ALERT SERVICE BULLETIN

NO. 206L-08-149

MODEL AFFECTED: 206L SERIES

SUBJECT: SUPPORT ASSEMBLY P/N 206-033-501-003 AND -004, INSPECTION OF

VIEW A Arm & Support Assembly

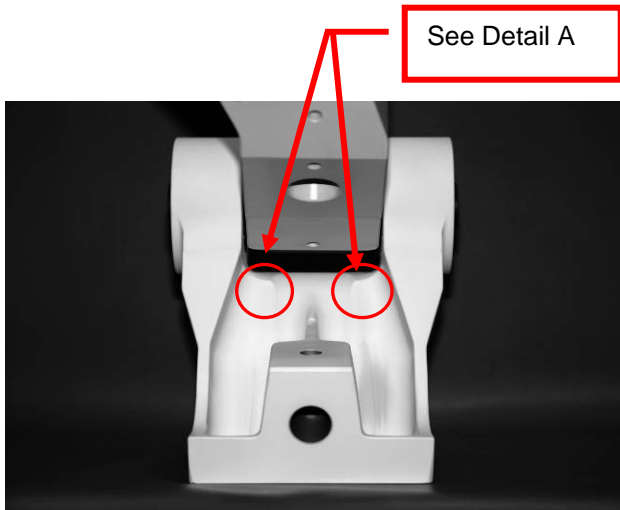
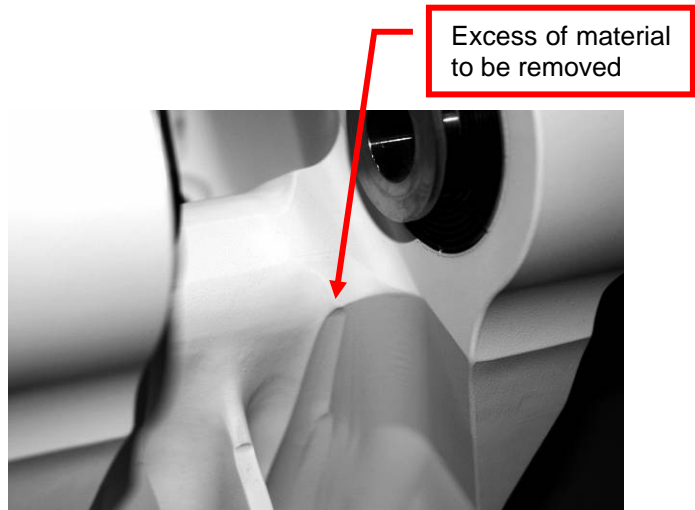
1. Gain access to the transmission arm and support assemblies.
2. Using a mirror and a bright light, inspect for fouling between the aft arm assembly and the support assembly at the area shown in Figure 1 view A. Inspect the L/H and R/H support.
3. If no fouling exists, make an entry in the helicopter records to indicate that this bulletin has been accomplished.
4. If fouling exists, proceed with Part II.

Inspect support
for fouling from
behind looking
forward

VIEW B Area of Fouling

FIGURE 1 Support Assembly sheet 2 of 2

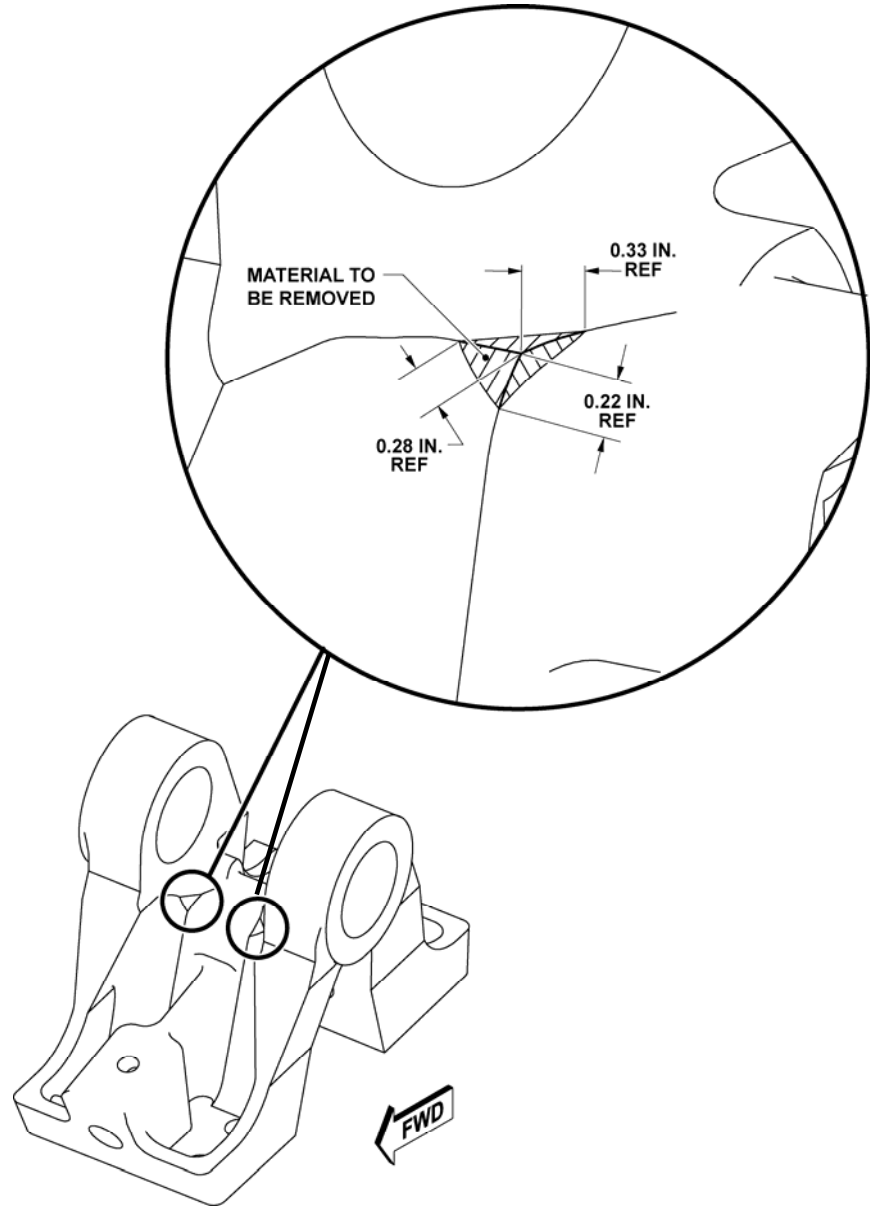
1. Remove aft arm assembly P/N 206-033-505.
2. Starting with a smooth cut hand file and then finishing with 220 and 400 grit abrasive cloth or paper (C-423), remove 0.100inch (2.54mm) material maximum from the support assembly as shown in Figure 1 sheet 2 Ensure smooth transition to the surrounding areas. Break all sharp edges in repaired areas. Repeat process for the opposite side.

Excess of material
to be removed

Remove 0.100in (2.54 mm) maximum from top to base of the defined pyramid.

After material removal, minimum wall thickness shall be above 0.300 in (7.62 mm)

Smooth transition is not shown for clarity.
